June 12, 2024

RE: Proposed Torrance Del Amo Project

Recognized Environmental Conditions from Disposal/Waste Pond and Four Above Ground Storage Tanks at Former Oil Operations: Subsurface Investigation of Methane, Hydrocarbons and Solvents
2325 Crenshaw Boulevard, Torrance, California

SWIMS Database results with five circles around oil wells
and methane warning (6/11/2024)

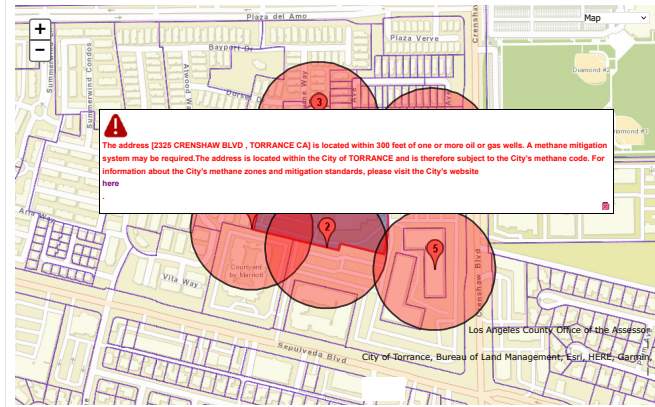
As part of my investigation of the documented environmental concerns at the subject property, I contacted the Los Angeles County Methane hotline on May 14, 2024. I received a return phone call from Mr. Jonathan Rinella, PE, Associate Civil Engineer, Los Angeles County Public Works on May 15, 2024. Mr. Rinella, PE and we spoke for approximately thirty minutes. Mr. Rinella informed me there are potential subsurface environmental concerns after he simply entered the subject site address in the Los Angeles County Public Works Solid Waste Management System (SWIMS) "Do I need Methane Mitigation?" website <https://dpw.lacounty.gov/epd/swims/OnlineServices/search-methane-hazards-esri.aspx>. That search resulted five large circles around oil wells near/on the site (see *Exhibit A*) and contained the following alert:

The address [2325 CRENSHAW BLVD , TORRANCE CA] is located within 300 feet of one or more oil or gas wells. A methane mitigation system may be required. The address is located within the City of TORRANCE and is therefore subject to the City's methane code. For information about the City's methane zones and mitigation standards, please visit the City's website here.

LEVEL 1 SITE PLAN
 3/64"=1'-0"

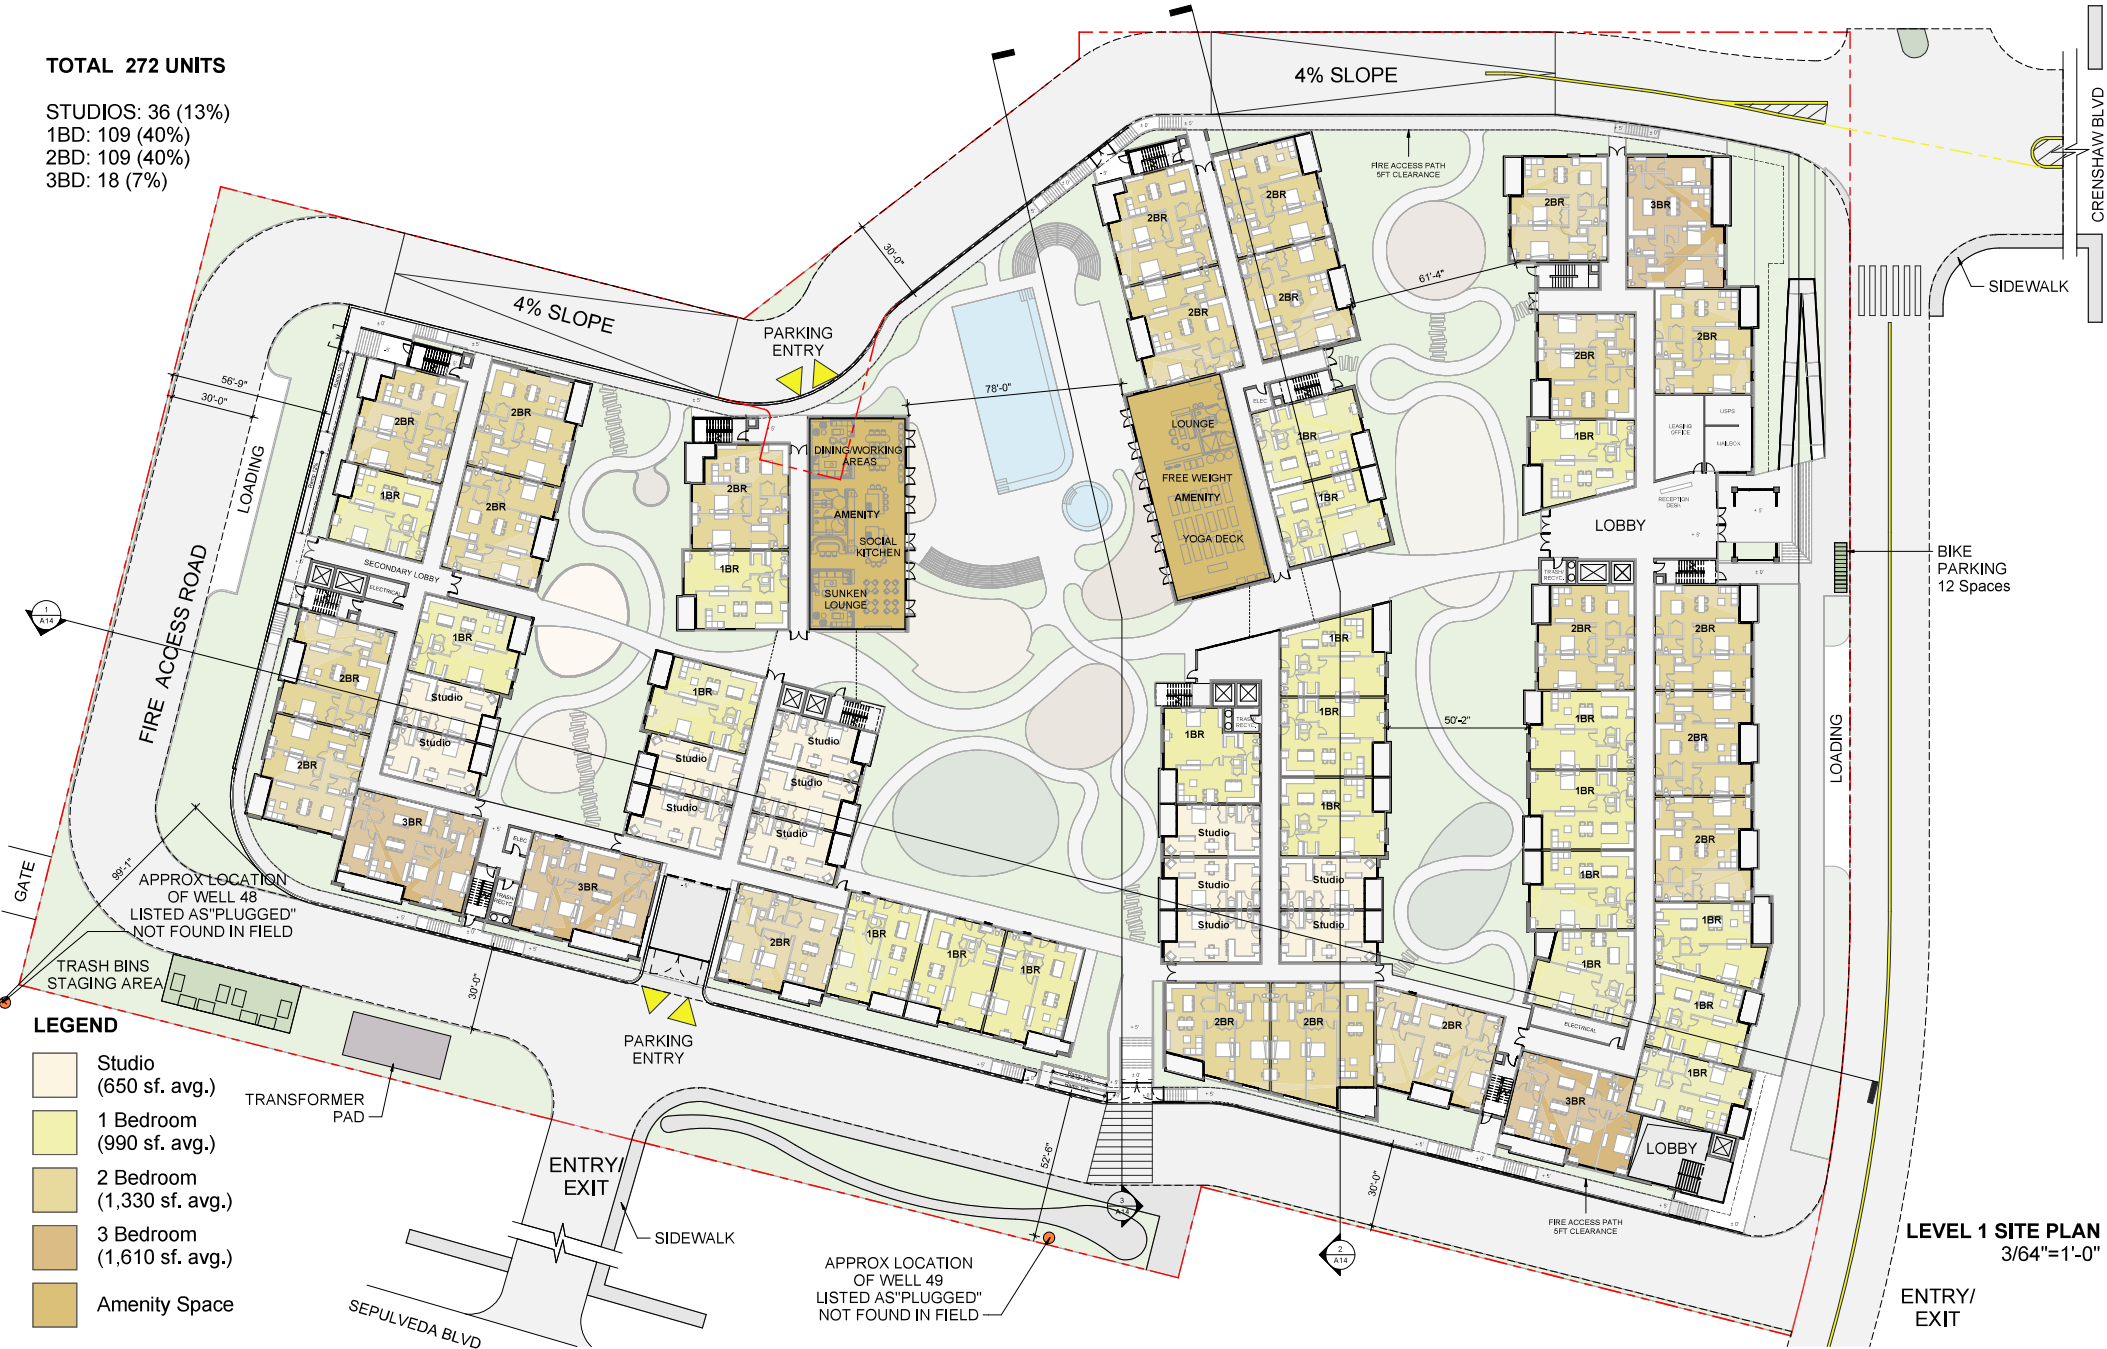
The first item is pdf 4 of 21 which is entitled "LEVEL 1 SITE PLAN" and it can be seen on the lower, middle portion of the page "APPROX LOCATION OF WELL 49 LISTED AS "PLUGGED" NOT FOUND IN FIELD" (Attached as *Exhibit B* and dated August 10, 2023). The four above ground storage tanks and the waste pond were not mapped but are described on page 14 in the Phase I Report dated July 2022 in the Observations section for the 1928 aerial photograph-attached as *Exhibit C*. The four above ground storage tanks were located within, near the center, of the proposed project area (Note: the former Chevron USA well number 49 is described in the 1928 aerial description). I have included pdf 806 of 889 of the July 2022 Phase I Report which is the 1928 aerial photograph, with the site boundaries in red, and in which the waste pond/four aboveground storage tanks are clearly visible (See *Exhibit D*). The 1947 aerial photograph description on page 14 of the July 2022 Phase I report states "The oil derrick and pond on the southern site boundary appears to have still been present." There is ample evidence from aerial photographs to warrant follow-up in the form of a subsurface soil investigation to ensure the soil gases does not contain elevated levels of contamination. Elevated levels of contamination left in place in the subsurface could expose local residents to environmental risks that may result in adverse health conditions.

1928 Aerial Photograph Shows Waste Pond, Four Above
Ground Storage Tanks and Chevron Oil Well 49 from
2022 Phase I Report (7/5/22)

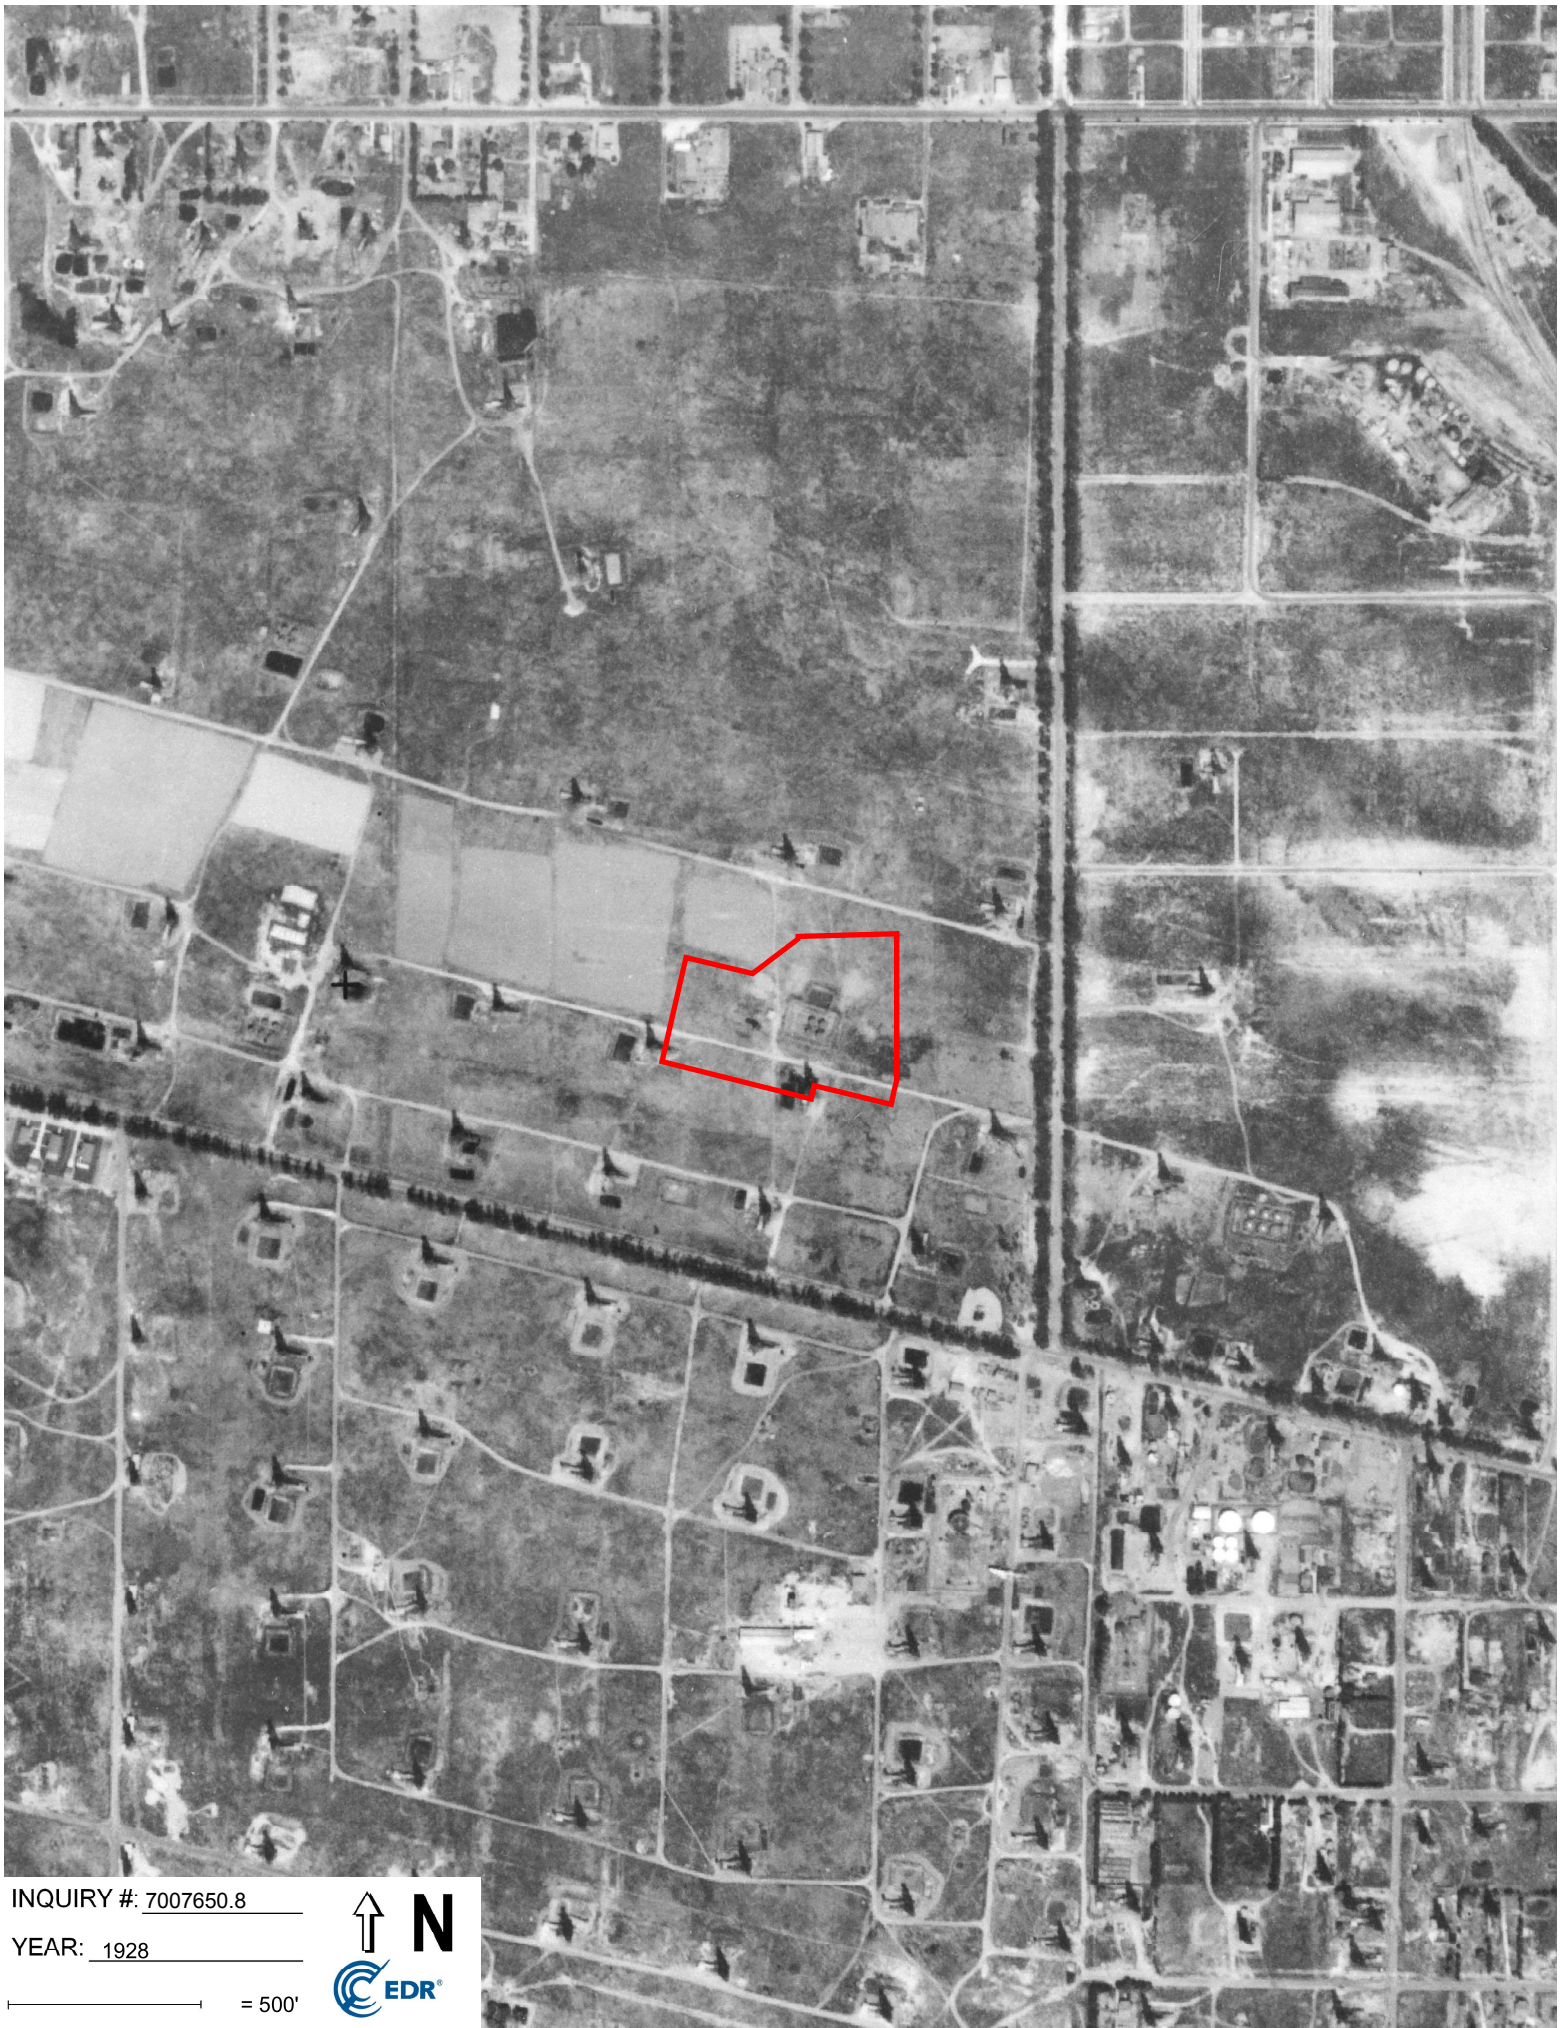
Year	Observations	
	Site	Adjoining and Adjacent Properties
1928 (1" = 500')	Four aboveground storage tanks (AST) surrounded by a soil berm and what appears to have been a waste pond on the northern side of the berm were present near the center of the Site. An oil well derrick (likely the former Chevron USA well number 49) and waste pond were present at the southern site boundary. An unimproved road was present across the southern portion of the Site.	Oil well derricks and waste ponds were present at approximate 450-foot-intervals west, east, and south of the Site with one (likely former Chevron USA well number 48) adjacent to the southwest of the Site. Oil derricks and waste ponds were also present north of the Site, but with larger spacing between them. Improved roads were present in the locations of present day Crenshaw Boulevard and Sepulveda Boulevard.
1947 (1" = 500')	The resolution of the photo is poor, but the four ASTs and pond appear to have been removed and the berm graded down/spread out on the surrounding ground surface. The oil derrick and pond on the southern site boundary appears to have still been present. What appears to have been a farm field was present in the northeastern portion of the Site.	Conditions appear to have been somewhat similar to those observed on the 1948 photo except that farm fields were present on adjoining properties east and northeast of the Site and an airfield or railroad and possible military or industrial facility are partially visible east of Crenshaw Boulevard.
